REGULAR OPEN MEETING OF THE UNITED LAGUNA WOODS MUTUAL ARCHITECTURAL CONTROL AND STANDARDS COMMITTEE*

**Thursday, August 15, 2024 – 9:30 a.m.
Laguna Woods Village Board Room /Virtual Meeting
24351 El Toro Road, Laguna Woods, CA 92637**

DATE: August 15, 2024
FOR: Architectural Control and Standards Committee
SUBJECT: Revision to Standard 20: Balcony, Patio and Atrium Covers

4.0 **ATTACHMENT TO BUILDING**

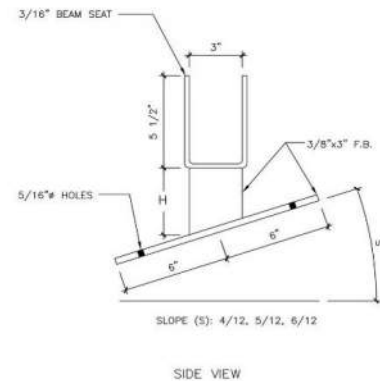
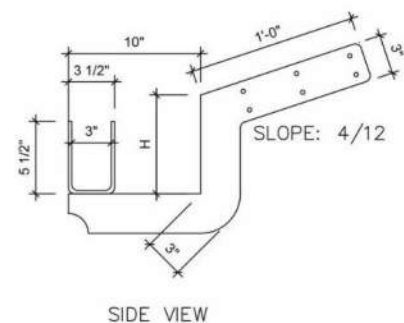
- 4.1 All coverings must not alter existing roofing eaves or perimeters.
- 4.2 All coverings must not alter or interfere with existing guttering systems.
- 4.3 Attachment to building for all roof components will be per one of the following options:

- B. Raised roof bracket as manufactured by “Beam Lift” or approved equal. Note: Any roof modifications required for installation of bracket must be reviewed and approved by a licensed roofing contractor.

- C. Rafter bracket as manufacture by “Beam Lift” or approved equal. EXCEPTION - Building guttering may be modified to 5 inches wide to accommodate rafter bracket installation
